Work Order ID 108678

Item Name: Crosstube Turning Detail

| DRAWING NO. D412-664-243 | TITLE CROSSTUBE ASSEMBLY (412 HI AFT) | REV. E | DART AEROSPACE LTD ENGINEERING ORDER | | D.E.O. NO. D412-664-243-E-4 | SHEET NO. SHEET 1 OF 3 | SCALE NTS |

REMOVED ABRASION STRIP IN FAVOR OF A THIN LAYER OF PROSEAL 890. UPDATE INSTALLATION OF CHAFING SHIELDS AND REDUCE TORQUE TO 40-50 IN-LBS. THIS ENGINEERING ORDER SUPERCEDES DEO D412-664-243-E-1.

**D412-664-243
ASSEMBLY DETAIL**

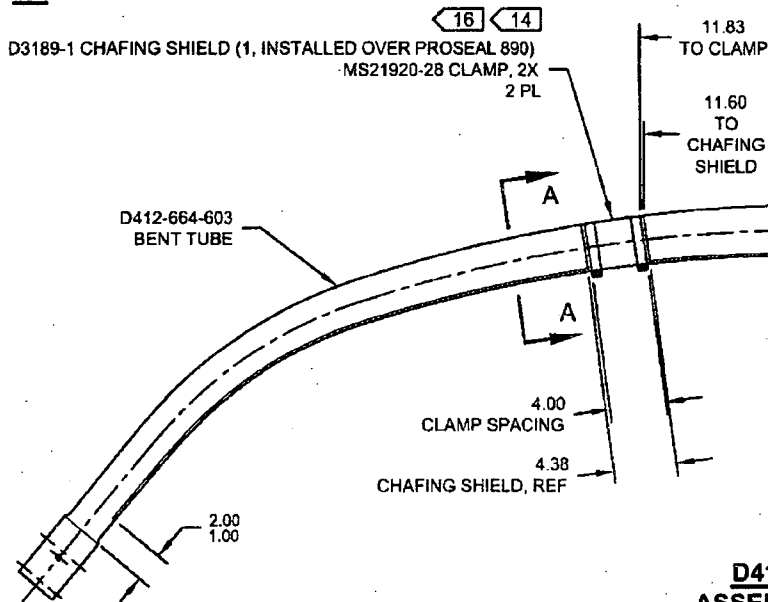
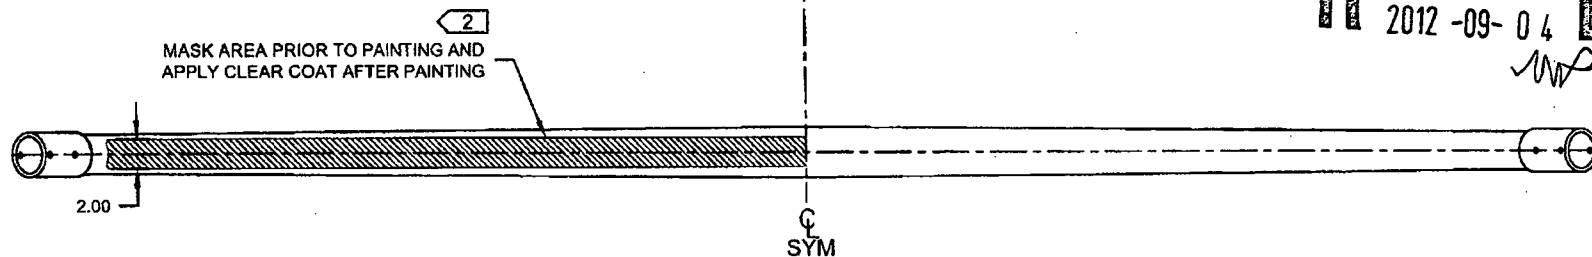
IS:

D3189-1 CHAFING SHIELD (1, INSTALLED OVER PROSEAL 890)
MS21920-28 CLAMP, 2X
2 PL

WAS:

D2856-600-1009 ABRASION STRIP
D3189-1 CHAFING SHIELD (1, INSTALLED OVER ABRASION STRIP)
MS21920-28 CLAMP, 2X
2 PL

SECTION A-A
CHAFING SHIELD DETAIL
VIEW ROTATED, NOT TO SCALE

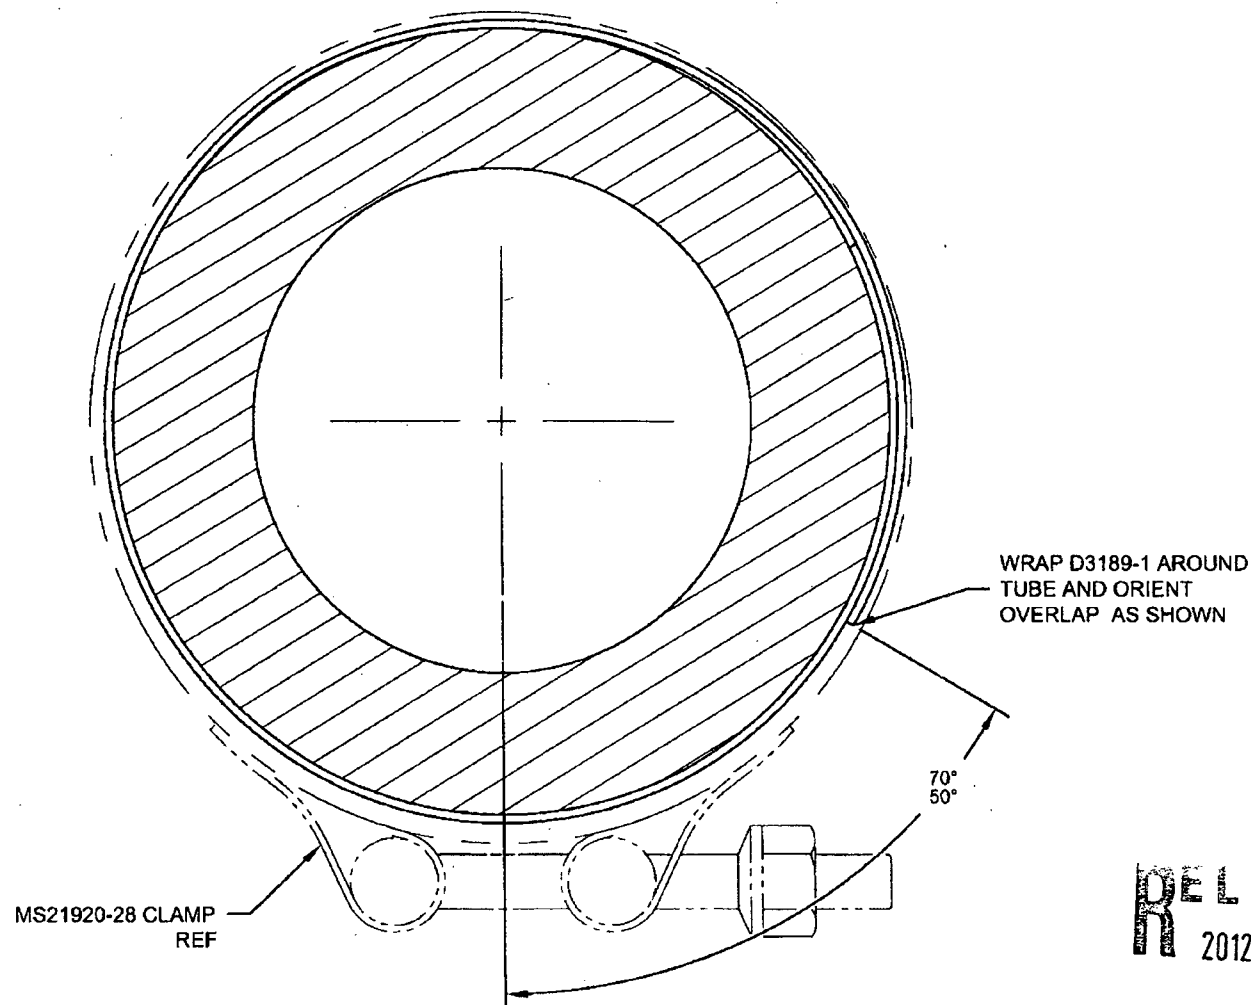
| DRAWING NO. D412-664-243 | TITLE CROSSTUBE ASSEMBLY (412 HI AFT) | REV. E | DART AEROSPACE LTD ENGINEERING ORDER | D.E.O. NO. D412-664-243-E-4 | SHEET NO. SHEET 3 OF 3 | SCALE NTS |
